REMARKS

Applicant : Alexei A. Erchak et al.
Serial No. : 10/723,987
Filed : November 26, 2003
Page : 12 of 12

Amendments to the Drawings:

FIG. 14

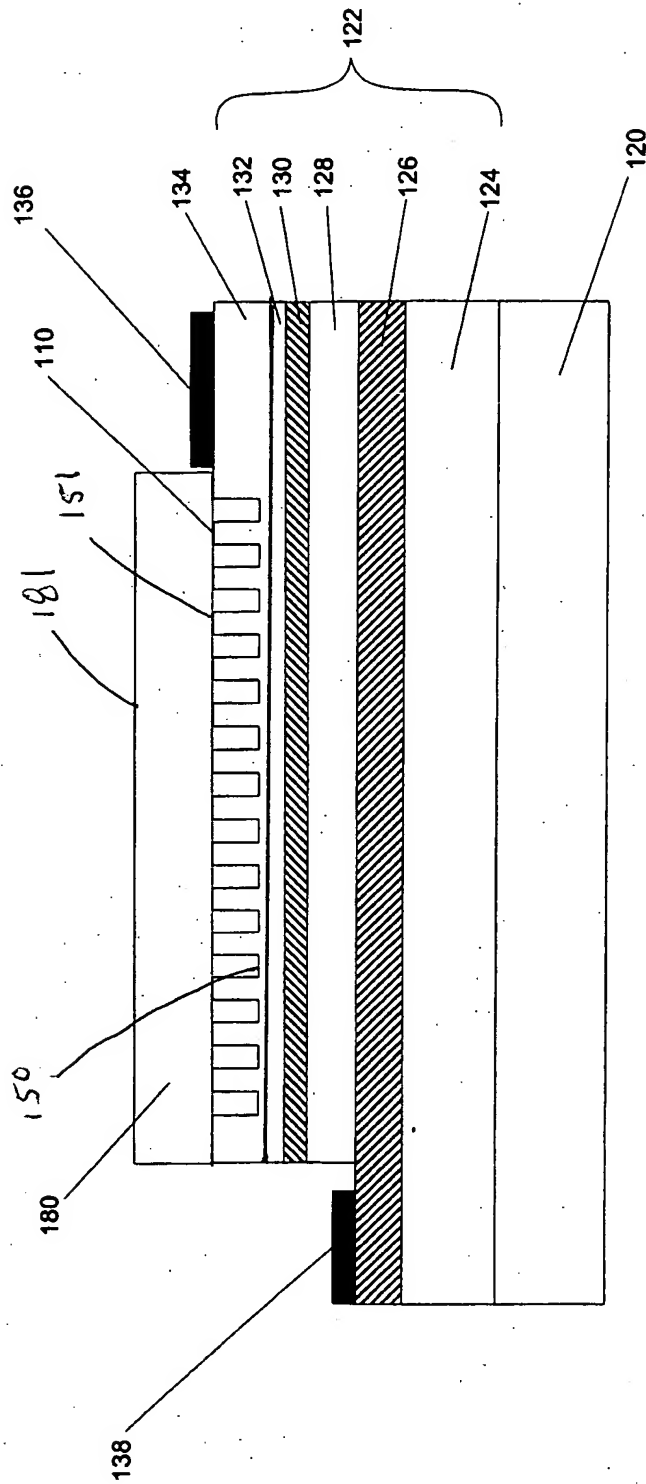
The Examiner objected to the drawings for including certain reference characters (146, 606 and 136) that, in the Examiner's view, were not included in the application as originally filed. However, reference numeral 146 was disclosed in the application as originally filed at page 14, line 12, and reference number 136 was disclosed in the application as originally filed in several locations, including, for example, at page 12, line 30. Applicants amended figure 17 to remove reference numeral 606 and its corresponding layer. Therefore, this objection should be withdrawn.

Please substitute the enclosed 16 replacement sheets of formal drawings for the drawings presently in the application. The attached replacement sheets of formal drawings include changes to Figs. 14 and 17 as indicated in the annotated sheets of drawings that include Figs. 14 and 17. The attached replacement sheets of formal drawings also include newly added Figs. 20-22.

FIG 17

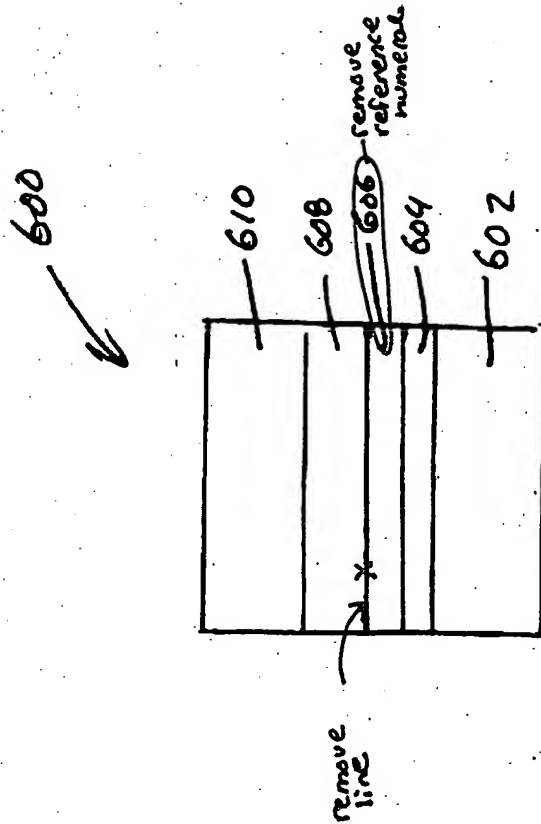
The Examiner also objected to the drawings for failing to show every feature specified in the claims. In particular, the Examiner stated that the drawings failed to show a p-ohmic contact layer between the layer of p-doped material and layer of reflective material. But, this feature is shown, for example, in FIG. 16 and described, for example, in the application as originally filed at page 26, lines 17-25. In addition, the Examiner stated that the drawings failed to show embodiments in which the pattern extends beyond the first layer. Applicants added new FIGS. 20-22 to address this basis of the objection. In view of the foregoing, this objection should be withdrawn.
